# iMAC RO4 V2 MODULE

| Summary | |
|---|---|
| **Purpose** | To inform customers of the iMAC RO4 module upgrade |

IMAC RO4 V2 Module
IMACB169 Version 1
04 DEC 2017

*Figure 1: New RO4 V2 Wiring Diagram*

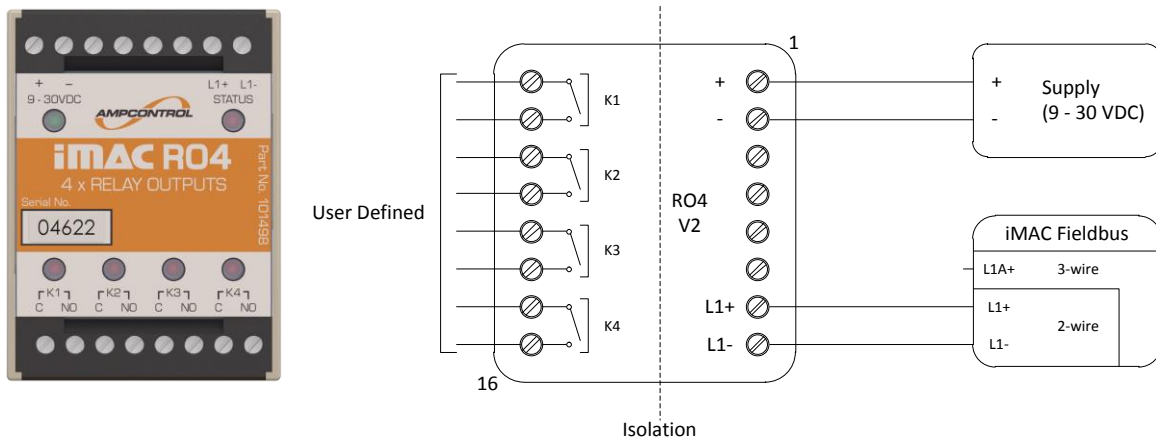
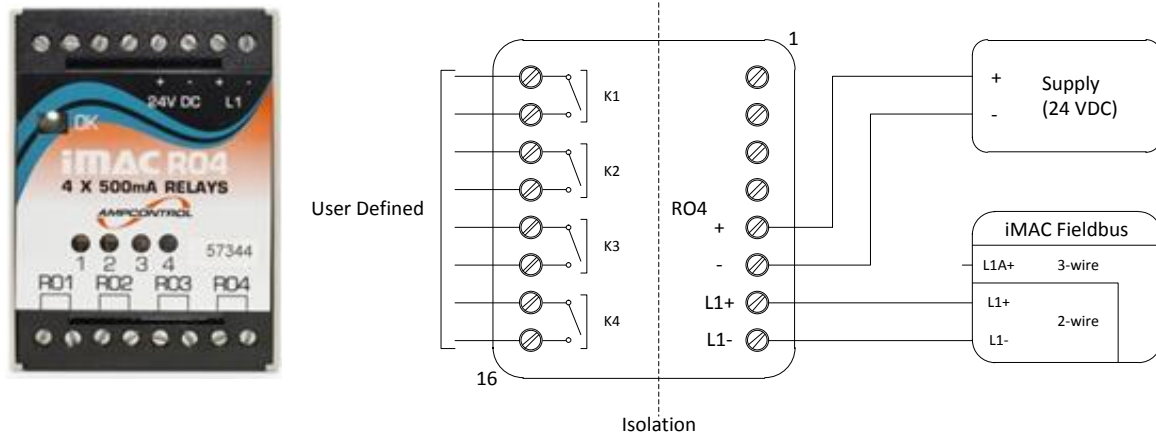
The new RO4 V2 module has a fresh new look, but is housed in the same DIN rail enclosure. The Relay output terminals and the iMAC fieldbus terminals are in the same location as before, however the DC +/- power supply terminals have been relocated to the left most side of the terminal strip.

### Key Notices
- New RO4 V2 module to address RO4 V0 and V1 component obsolescence issues
- Utilises latest iMAC hardware/software platforms
- DC +/- power terminals relocated to left most side of the terminal strip
- Wider DC power supply operating voltage range (9-30VDC)
- Improved safety features
